BRITISH GLIDING ASSOCIATION

Technical Newsheet. TNS 11/82

<b>TITLE</b> T65 'VEGA' Central Elevator Hinge on Tailplane, Elevator Tongue & Pivot Bearings for Elevator Rocker Arm.	<b>T.I.No.</b> 104/T65 Iss.1
<b>CLASSIFICATION</b> C.A.A. Mandatory	
<b>COMPLIANCE</b> Inspection to be carried out before the next flight unless LTO 'Elevator & Canopy Jettison Mechanism', 20th August has been carried out.	
<b>OBJECTIVE</b> To ensure structural integrity of the central elevator hinge on tailplane elevator drive tongue and to inspect the pivot bearings for the elevator rocker arm assy. Also to reinforce central elevator hinge on tailplane.	
<b>JUSTIFICATION</b> Cracking and a lack of stiffness has occurred in the area 'A' (Fig 1), the cause of which is attributable to heavy landings and/or excessive bearing loads during elevator assembly.	
<b>APPLICABILITY</b>  All Slingsby T65A, C, D gliders, including spare tailplane/elevators expanding on CAA Airworthiness Directive No.008-08-82. (LTO 'Elevator & Canopy Jettison Mechanism', 20th August).

TITLE		T65 'VEGA' Canopy Jettison Mechanism	T.I. No. 105/T65
CLASSIFICATION C.A.A. Mandatory			
COMPLIANCE Inspection to be carried out before next fl

BERGFALKE SERIES.

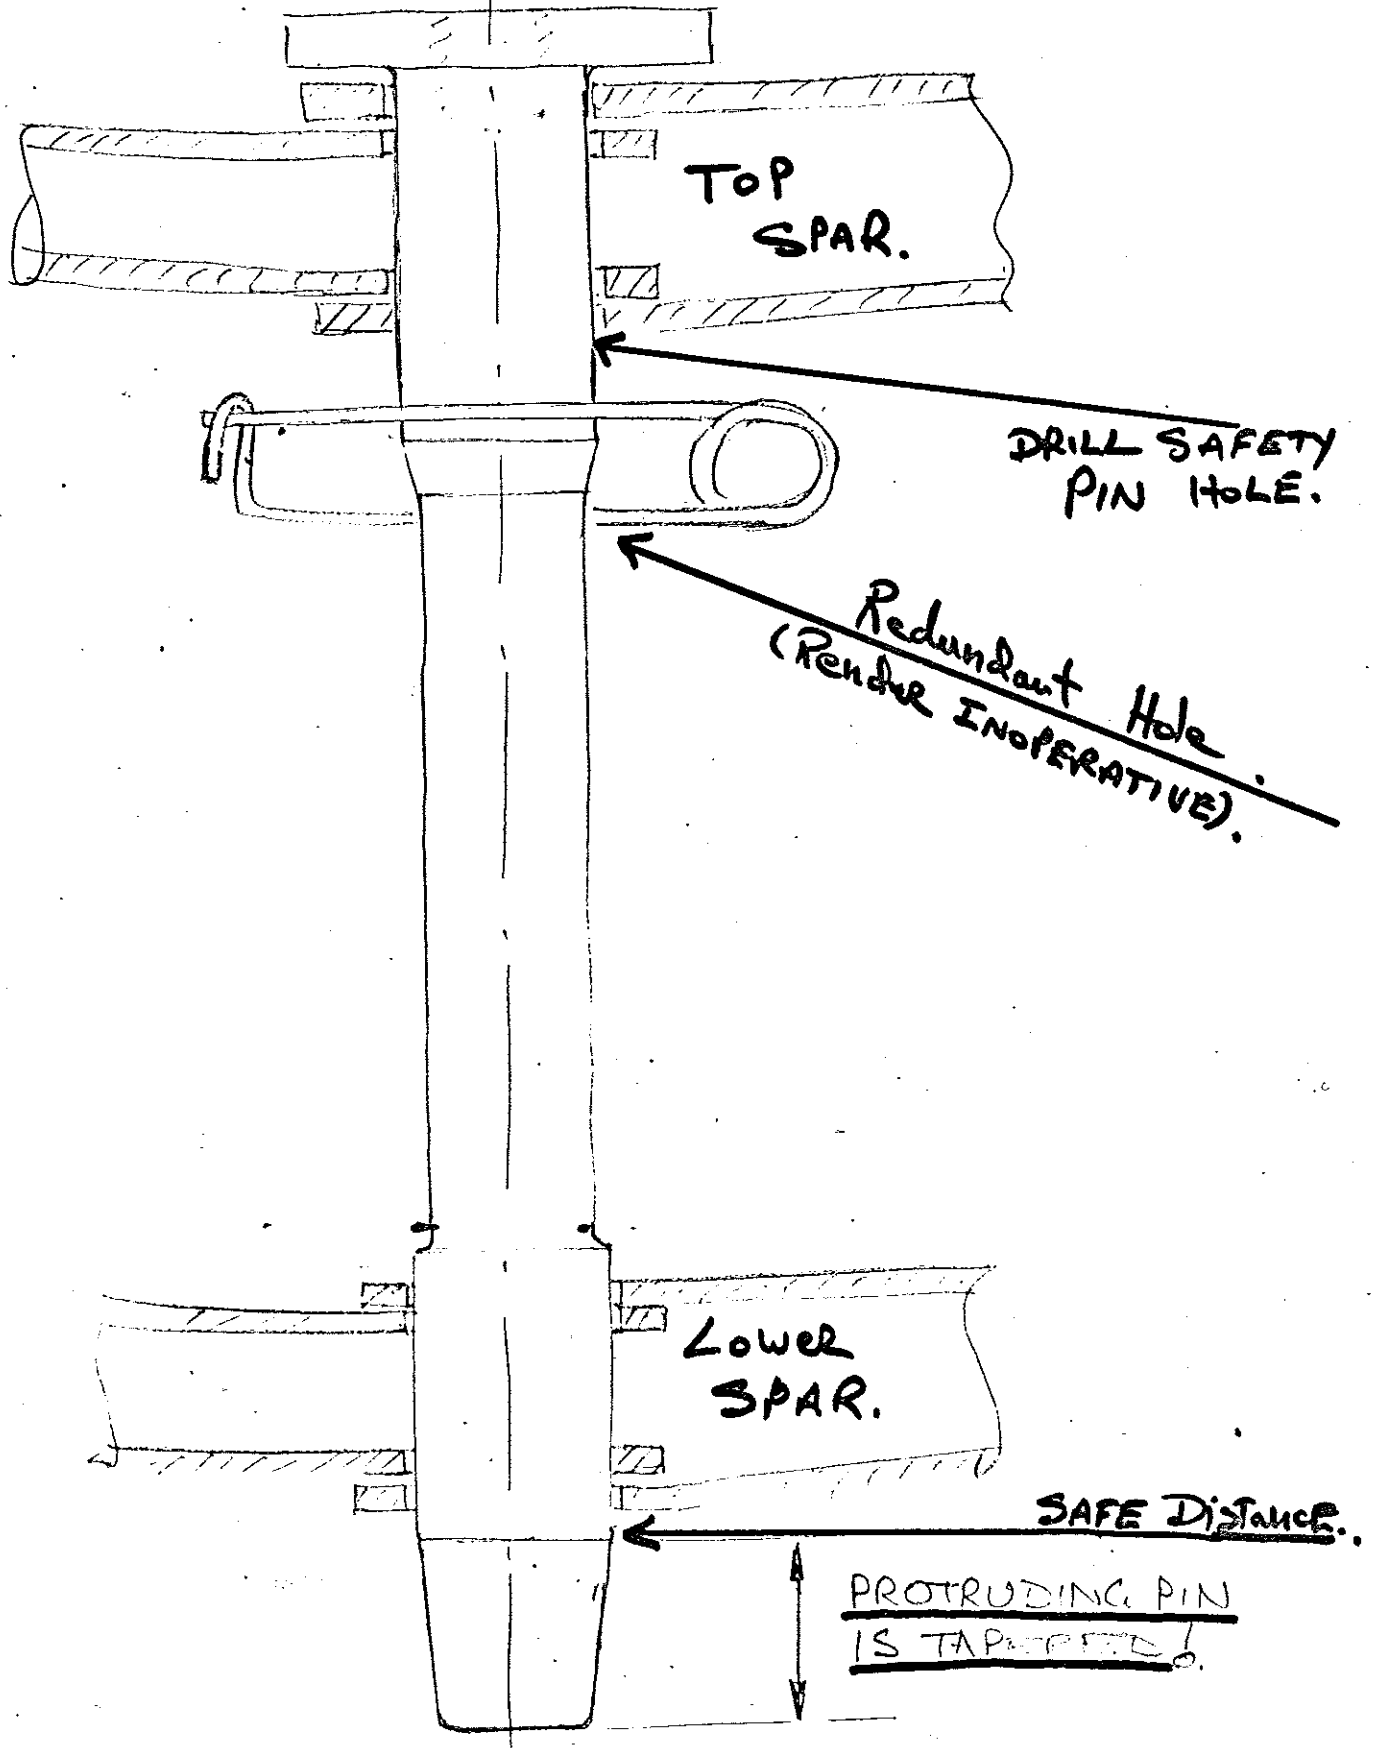
- 1.4 KAB - Seat Back structure may impair Escape by Parachute. The attached Note was circulated to all owners by BGA on 12/10/82.
- 1.5 Bergfalk Series (and other Scheibe designs?) MAIN WING PIN Retention. (Ref. attached sketch). To ensure that main wing pin remains fully engaged in lower spar fittings, and that the parallel portion protrudes a safe distance, the safety-pin hole may have to be drilled closer to the top spar fittings. The redundant hole must then be rendered inoperative. (Reported by Chris Batty - Cotswold Gliding Club.)

Additional mass balance on the rudder nose

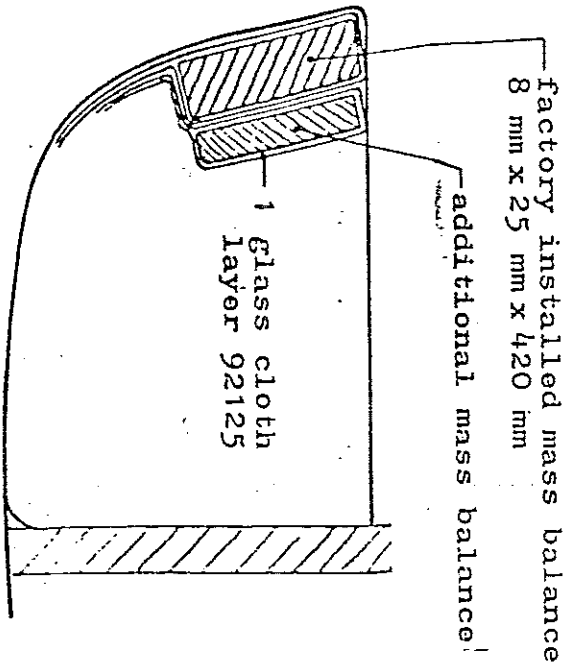
① If the values for the rudder are exceeded, the tail parachute must be removed, or an additional mass balance (lead strip) must be attached to the already factory installed mass balance on the lower part of the rudder nose. (See page 28).
